RGDSS Memorandum

To: Mike Sullivan, P.E. Colorado Division of Water Resources
Andy Moore, P.E. Colorado Water Conservation Board
From: HRS Water Consultants, Inc.
Eric J. Harmon, P.E., G. Eric Saenger, CPG
Subject: Hydrogeologic Review of Saguache Creek upstream of Town of Saguache,
Saguache County CO
Date: July 18, 2012

Figure 1: Study area of upper Saguache Creek valley: between the town of Saguache and the Saguache Creek stream gage.

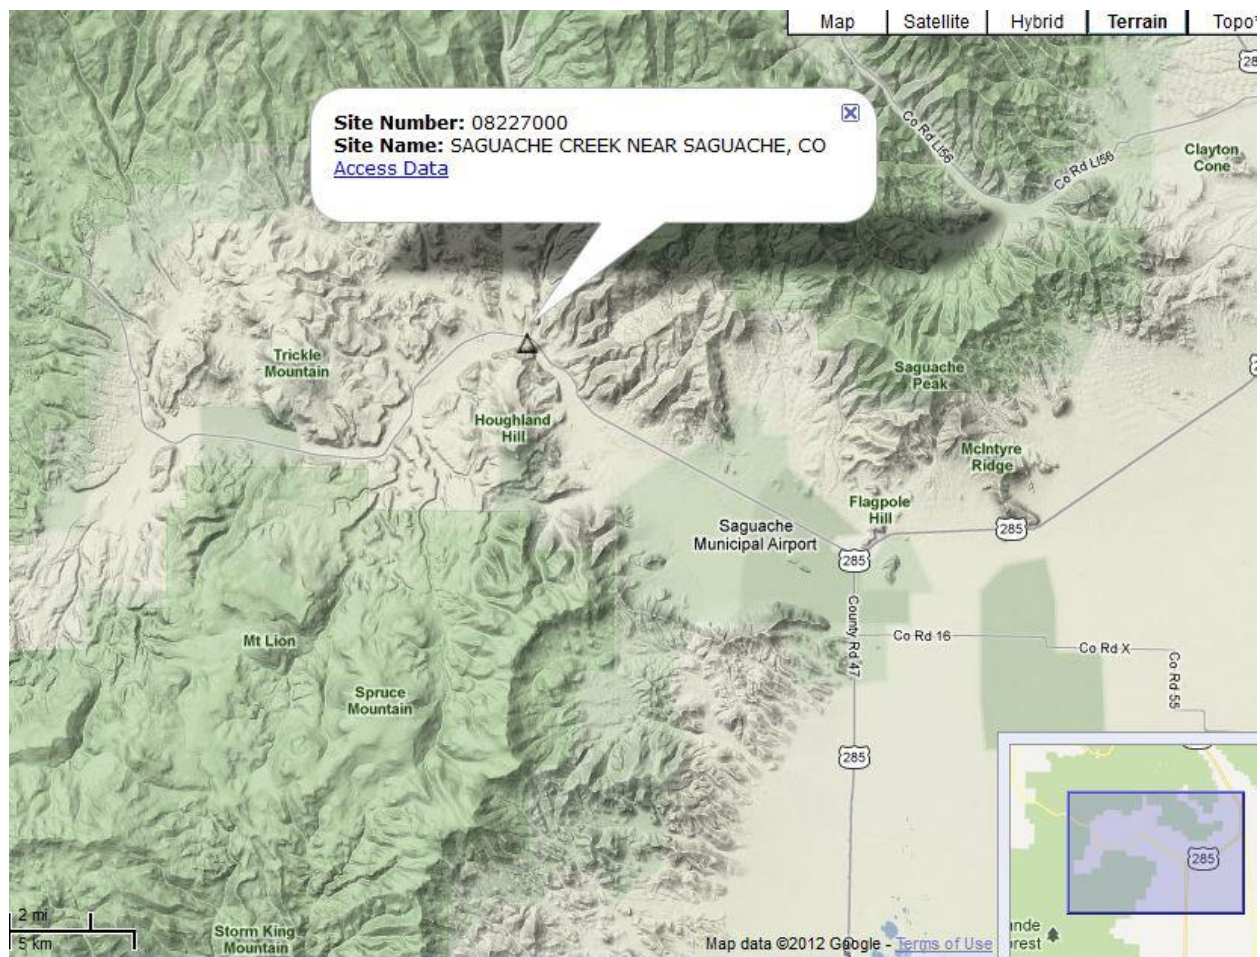
This memorandum summarizes the results of a review of the hydrogeology of the Saguache Creek valley in the area upstream / upgradient (west) of the town of Saguache as far as the Saguache Creek streamgage (see Figure 1). This work was done as part of HRS' participation in the peer review process to identify and implement improvements to the RGDSS. The study area for this hydrogeologic review included the reach of Saguache Creek generally upstream of Saguache, although the more detailed part of the review was done between the Saguache Creek streamgage and the town of Saguache (called "upper Saguache Creek" for the purposes of this memorandum).

There exists a geologic sequence of bedrock layers that comprise a relatively complete stratigraphic record of volcanic rock deposition in the study area. The bedrock formations are particularly well represented in Houghland Hill, located just south of the Saguache Creek streamgage (Bruns et al, 1971) (see Figure 1). However, with the exception of the deepest group of formations, Saguache Creek has eroded through the entire sequence of bedrock layers.
